May 2023

For your information, SafEye™ Quasar 900 commissioning kit was updated to include all six installation check filters for the factory-calibrated gas types: Methane (888260-1, 888260-2), Propane (888260-3, 888260-4), and Ethylene (888260-5, 888260-6), for warning and alarm levels, respectively.

Extended Commissioning Kit (888257)

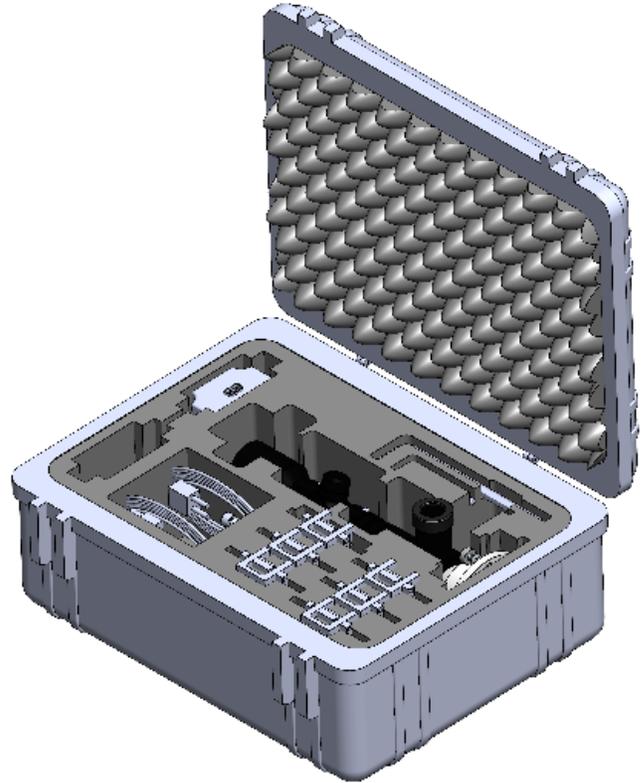
The back cover can be opened by hand without using any tool. If the back cover is tightly closed, please use any suitable tool, as shown in the example illustrated below.
